Timberyards SSDA Review

Marrickville
Landowner Group

Exec Summary (1) – Position & Main Planning Issues

6. Traffic, access + parking

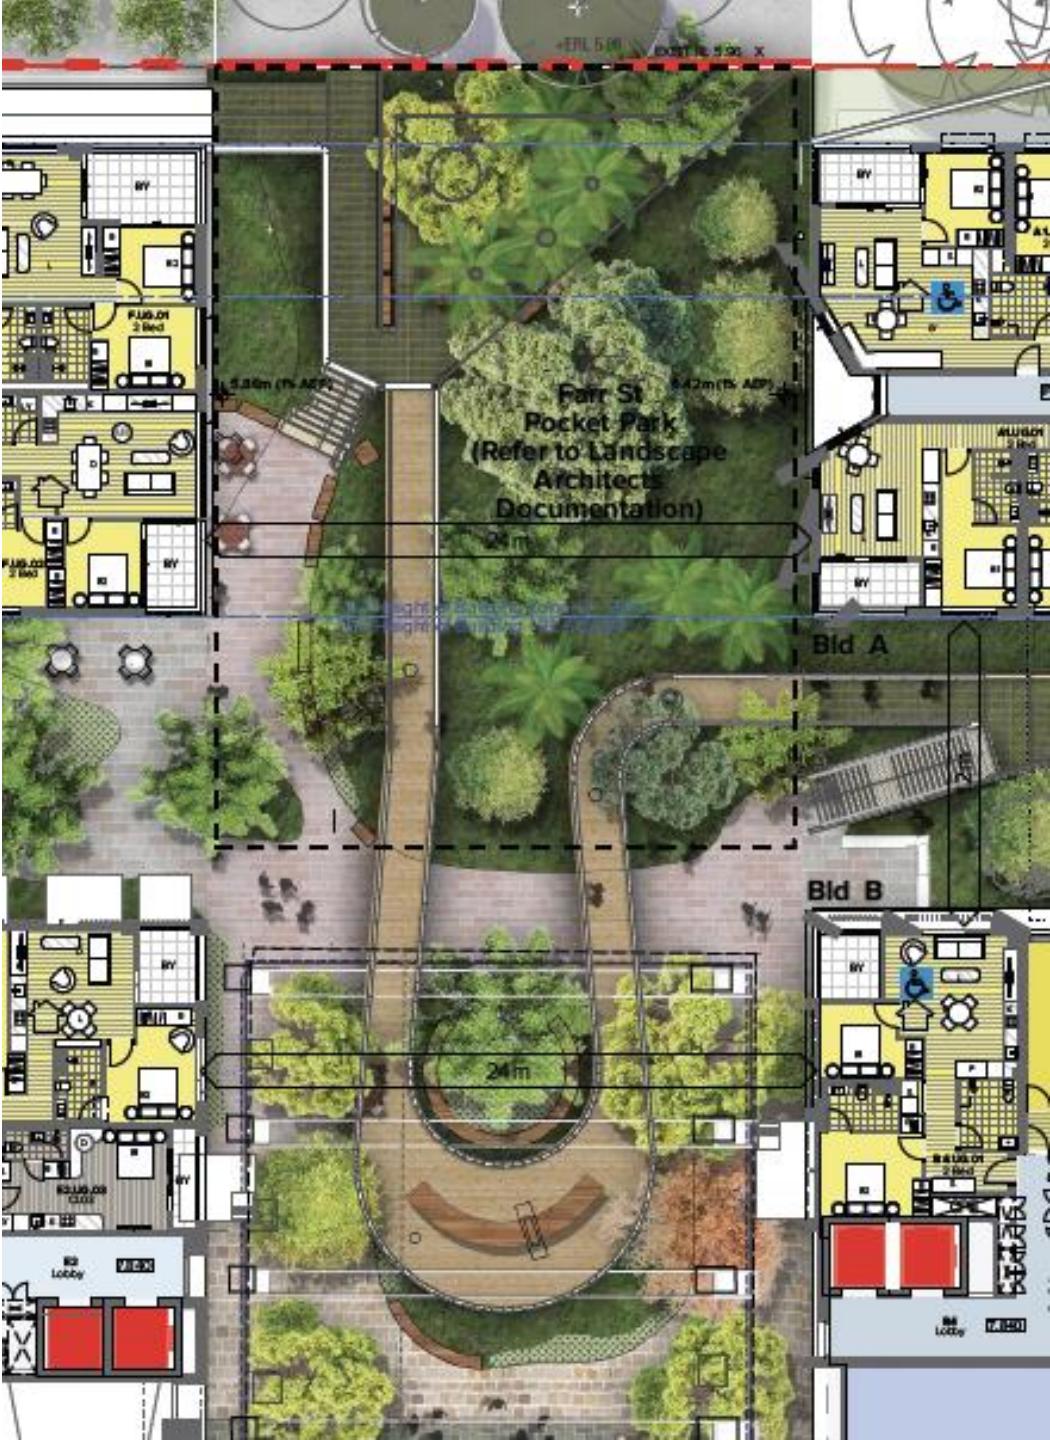
- Main vehicle access on Farr St (school frontage) – concentrates movements on a narrow residential street opposite a school; all vehicular access should be relocated to Victoria Rd / Mitchell St.

- Above-ground parking inflates built form and weakens active frontage along both Victoria Rd and Farr St.
- Victoria Rd signalised pedestrian crossing (exhibited then removed)

- Exhibited scheme included a signalised pedestrian (red) crossing on Victoria Rd near the site access.
 - This was removed at TfNSW's request on the basis it was too close to the Sydenham Rd intersection.

- The appropriate response is not to abandon the crossing, but to relocate a signalised pedestrian crossing further west at Victoria Rd / Mitchell St and require this as a condition.

- Pedestrian / through-site link – the alignment and building edges lend themselves to gating or control, rather than a clear, legible public link as envisaged in the DCP.

- Parking assumptions – low on-site parking and a “pay-per-space” model rely on optimistic mode share for BTR and co-living, with a real risk of overspill parking into surrounding streets.

7a. Through-Site Link – Design and Connectivity Issues

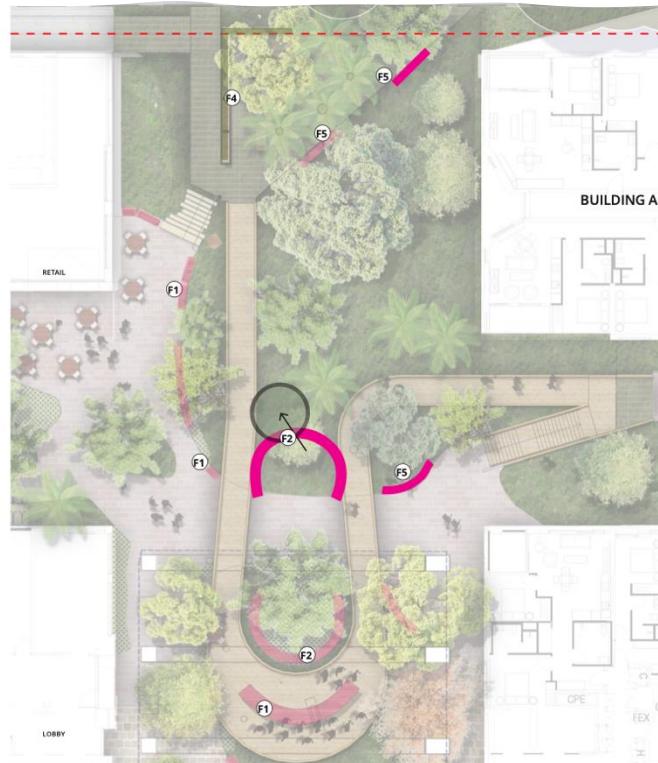
- Through site link key public benefit of sites rezoning
- Farr St “Link” is an internal, elevated boardwalk through private open space – not a direct, street-like path.
- Split levels, ramps and stairs make movement slow and inconvenient for everyday users.
- Dense planting, seating and level changes read as a semi-private garden, not an open public corridor.
- Narrow pinch-points create obvious locations for future fencing/doors – easy to close off.
- Outcome falls well short of the intended clear public connection between Farr Street/Wicks Park and Mitchell Street.

8b. Overshadowing Impact

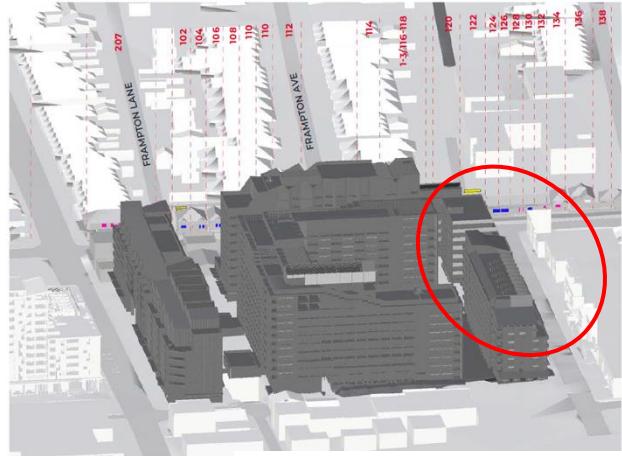
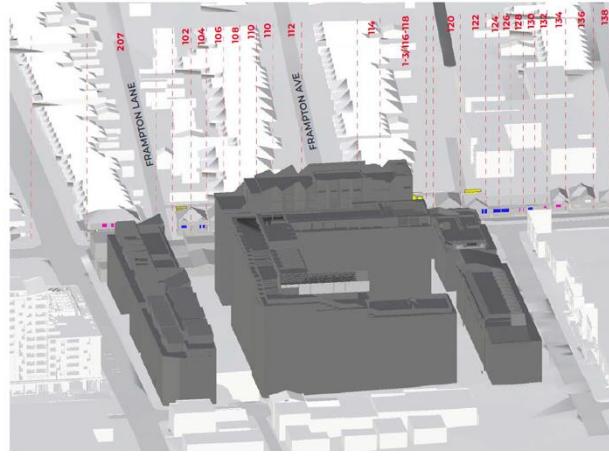
- Inner West DCP. 2.7.3 C – “Direct solar access to windows of principal living areas and principal areas of open space of nearby residential accommodation must not be reduced to less than two hours between 9.00am and 3.00pm on 21 June”;
- The applicant’s June 21 diagrams show the proposal compared with the applicant’s “20% bonus” envelope, the proposal still increases overshadowing, including:
 - extra shadow on Farr Street footpath, and
 - Sydenham Road properties, mid-winter sun to the main window dropping from about 2h15 to 1h45.
- There is no specific analysis of build G and therefore its direct impact is unknown.

Areas of impact of building seeking variation (G, F and A)
